FLOOD RISK ASSESSMENT and DRAINAGE STRATEGY

RESPONSE (2) to MSDC Flood Risk and Drainage Team Further Comments

Class Q Barn Conversions Prior Approval Application

Hammonds Mill Farm Estate Hassocks West Sussex

Section 2 at overflow stream at culvert
0264/FRA S2 revA

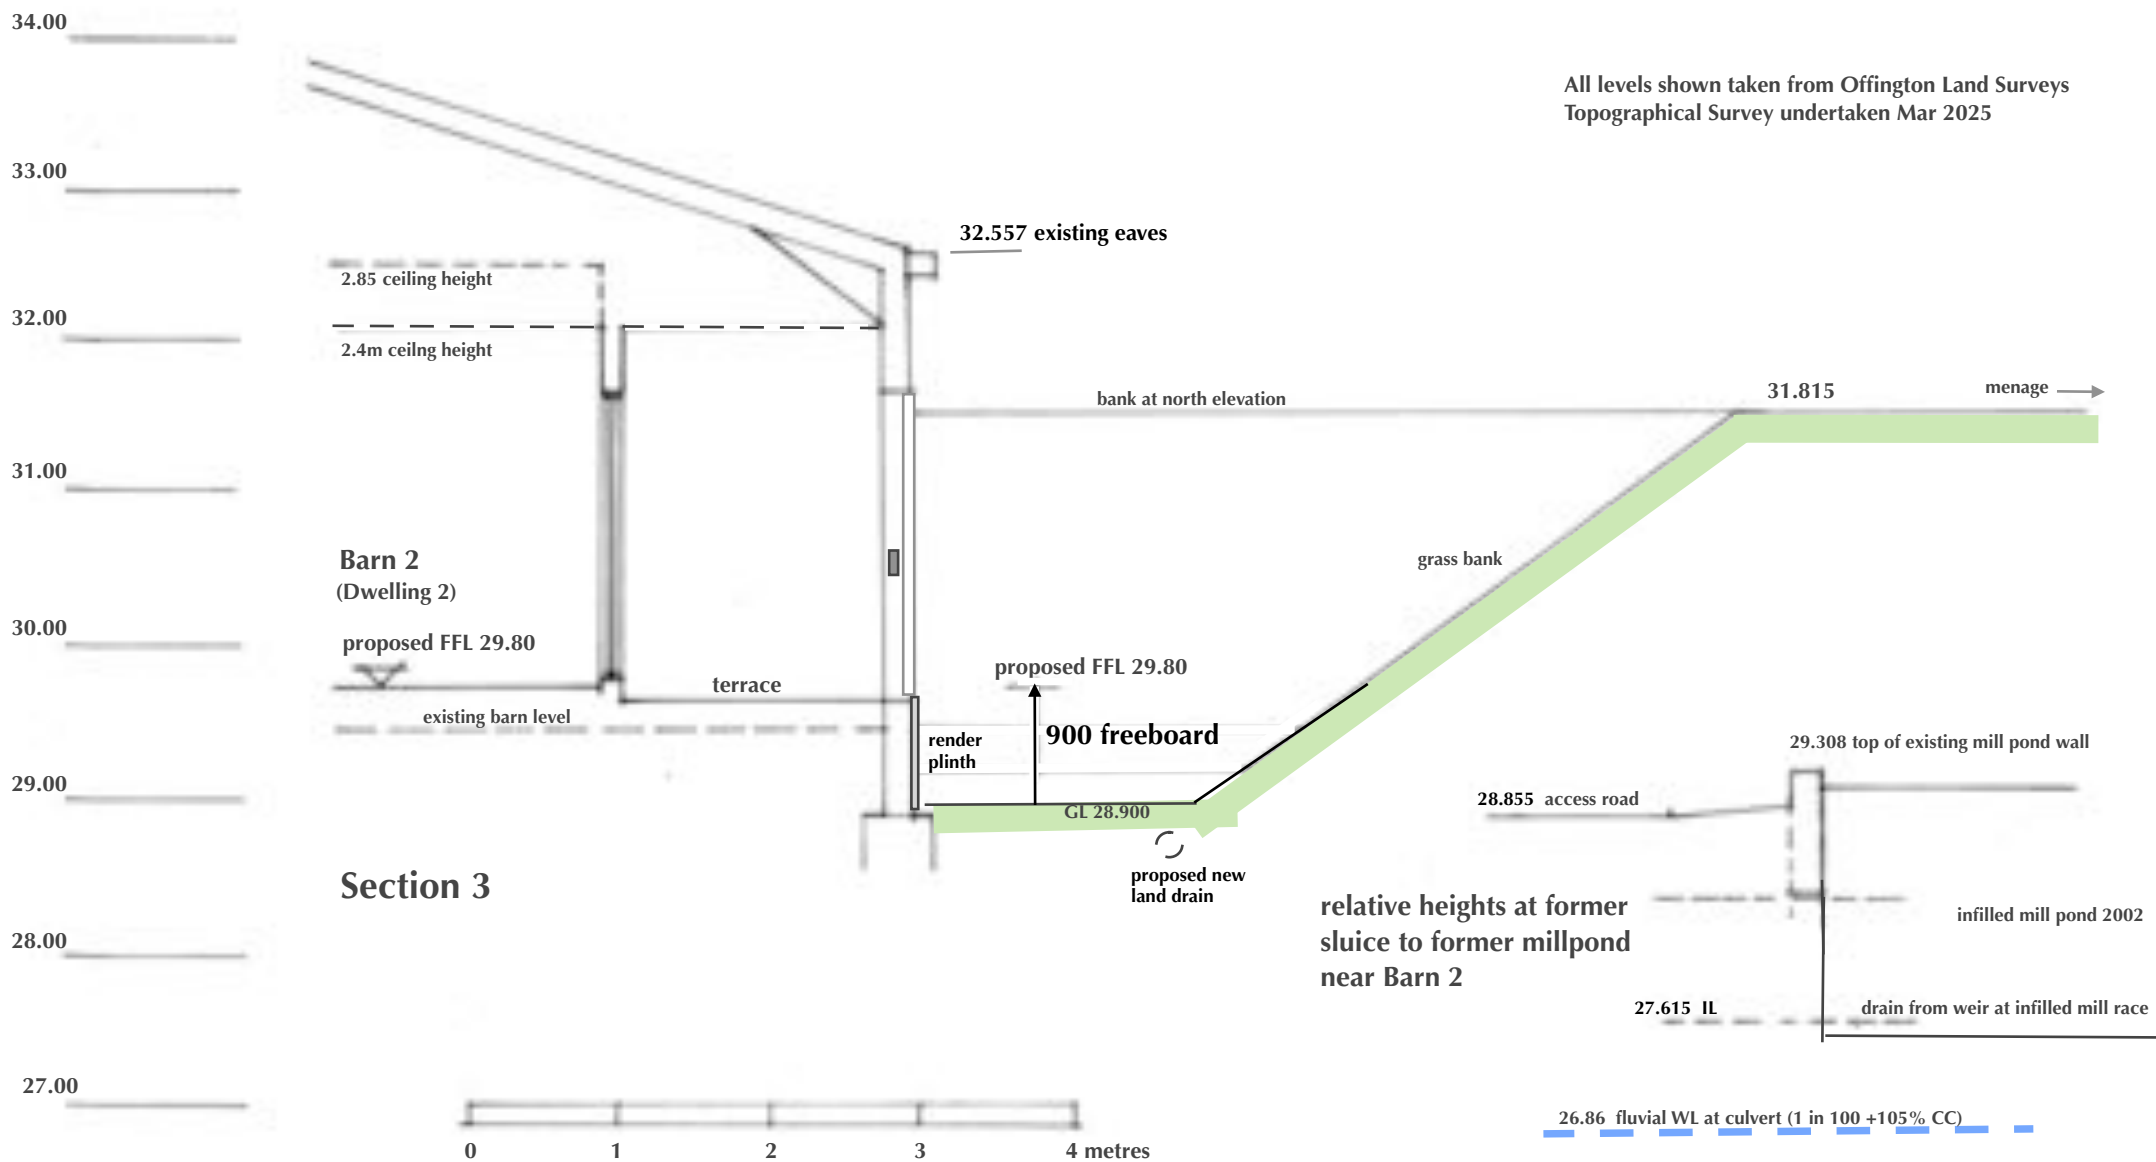
- 1.11 The site sections at Barn 3, included in the updated FRA have been amended to reflect the 27.75m AOD proposed FFL.

See Appendices: Site Section 1, Site Section 2

SECTION 3

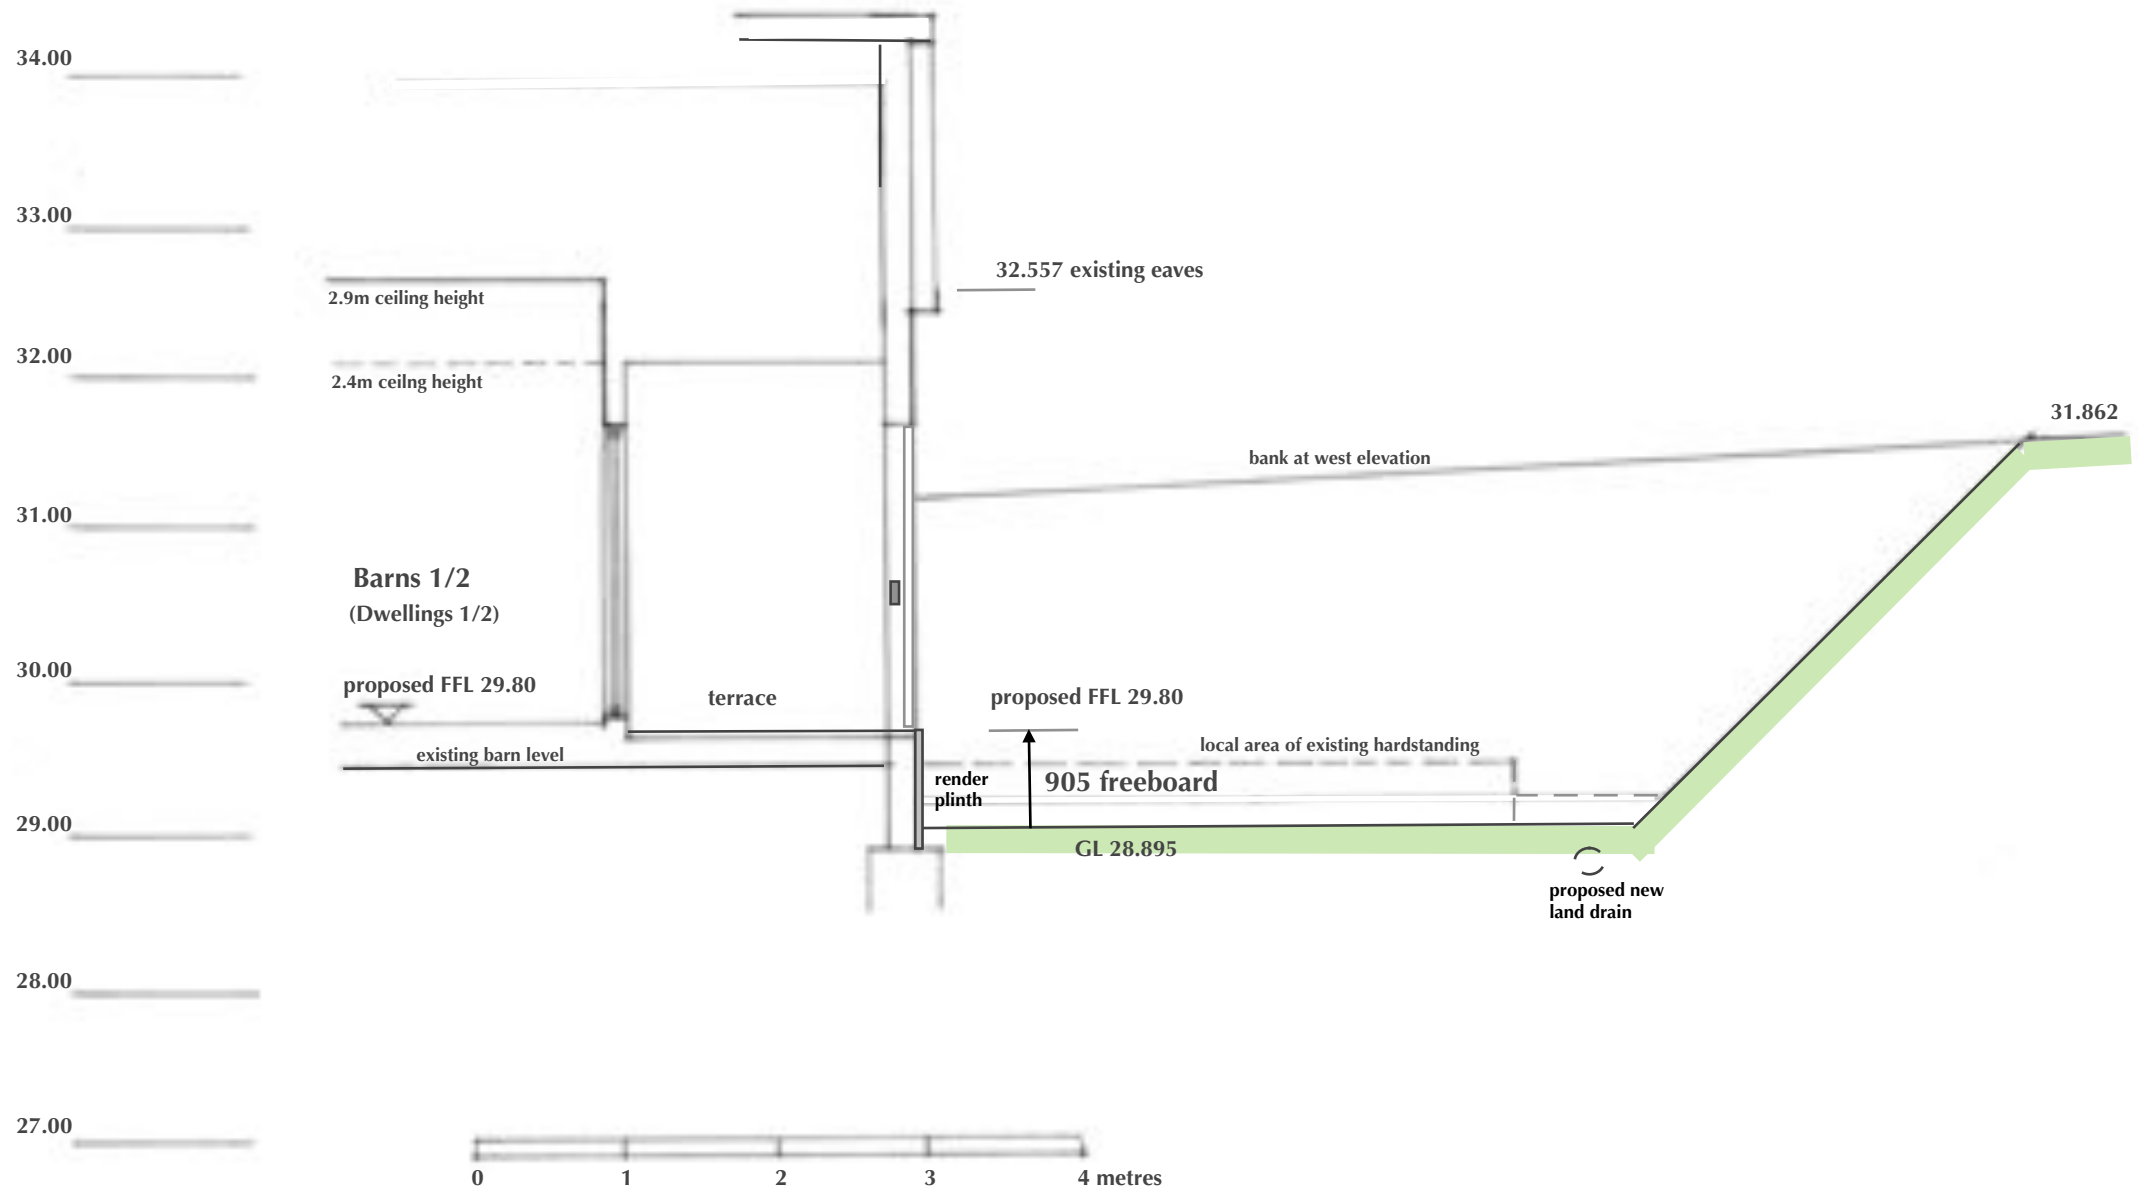
- 7.9 Proposed finished floor levels are 29.80, as in the updated Flood Risk Assessment, which is confirmed as 905mm above the highest adjacent external ground level. The existing concrete floor levels of the barns are between 570mm and 740mm above the adjacent external ground levels and therefore a flood resilience floor height addition of between 165mm and 335mm is only required, which is broadly consistent with adding insulation and a floor screed to meet current building regulation thermal standards for dwellings. This has been accepted by the EA in their consultation response to MSDC.

See Appendices: EMAIL EA Consultation Response to MSDC (Jul 2025) SITE SECTION 3, SITE SECTION 4
